DE LA VEGA
P.O.A.D.P.
JOB NO. 5020.01 DATE: 5/30/2001 (REVISED)

POADP APPLICATION

Re: De La Vega / Peerman

MDP/POADP # 721

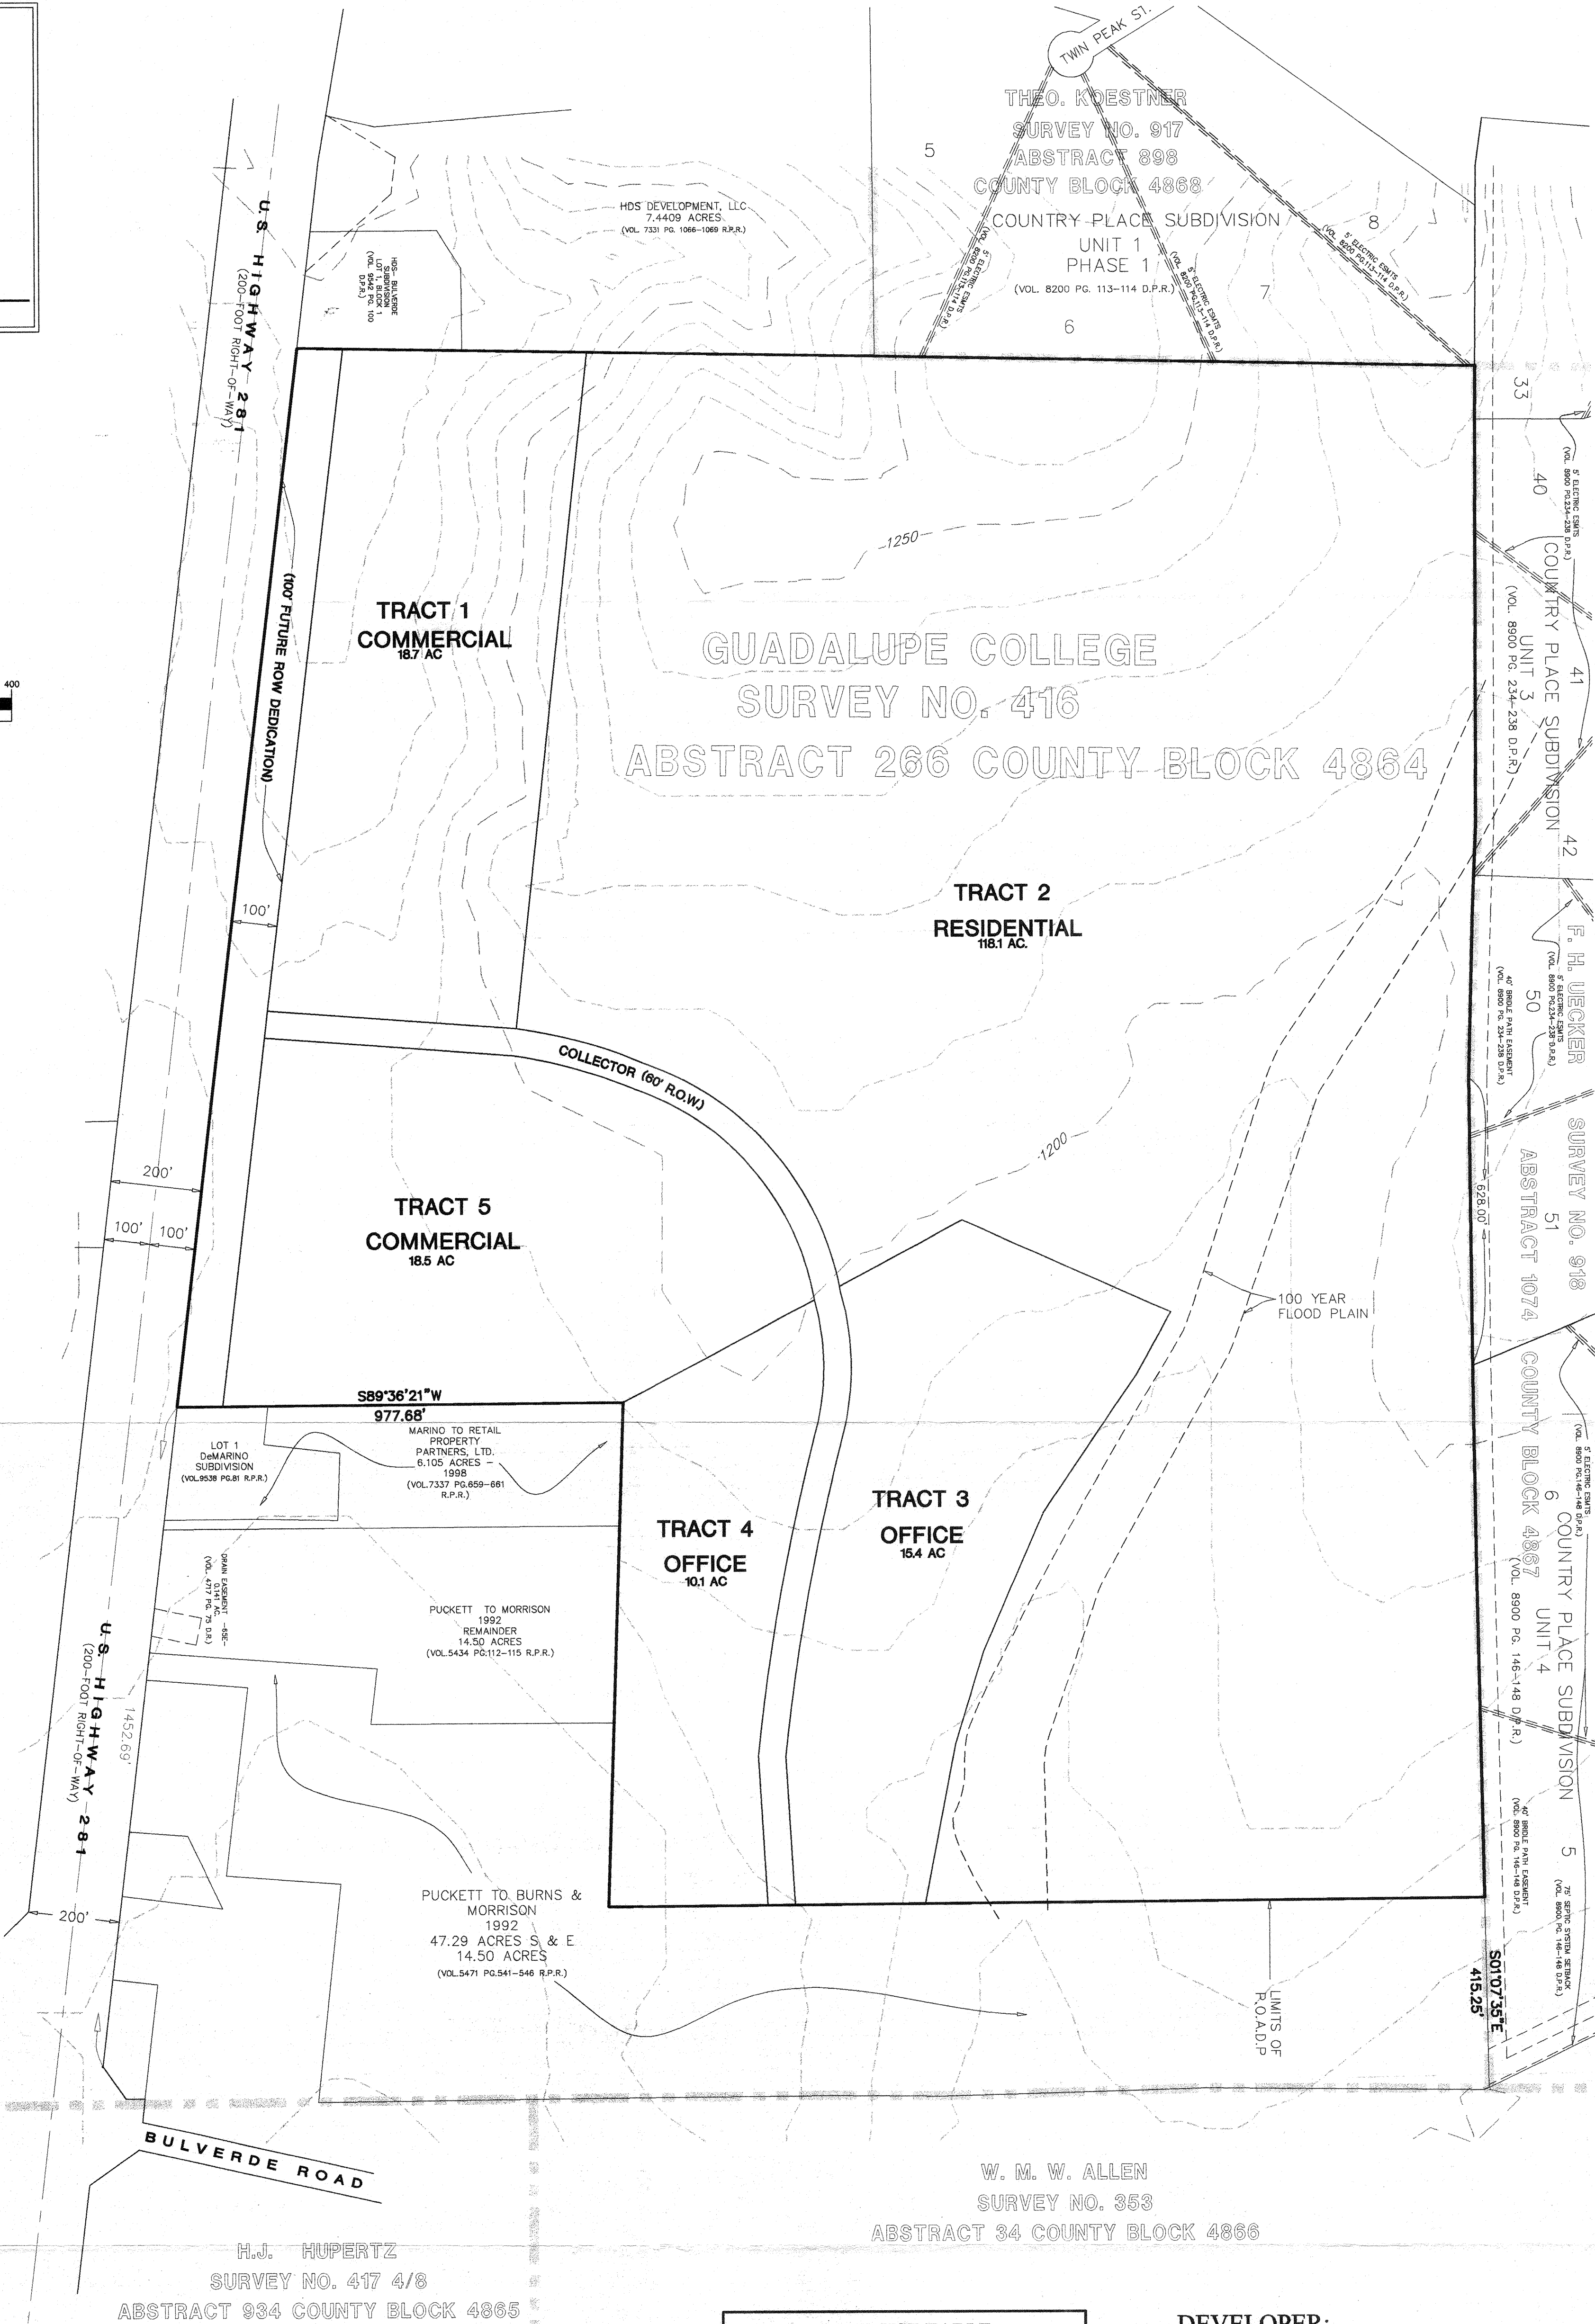
POADP 233 shows 60' collector connecting to Smithson Valley
Rd not Bulverde. Explain.

Comments: ^{Drainage} Would like to see 1 Street + lot layout

Streets longer than 1200' in length require
Traffic Calming, Preferably Islands.

Cul-De-Sacs longer than 500' require 30' pavement
+ 120' Row diameter.

Will Require minimum 300' ROW on Hwy 281.

Comments: US. 281 IS ON THE MTP AND TXDOT SYSTEM
REQUIRING A MIN. OF 110' ROW AND TXDOT RELEASE
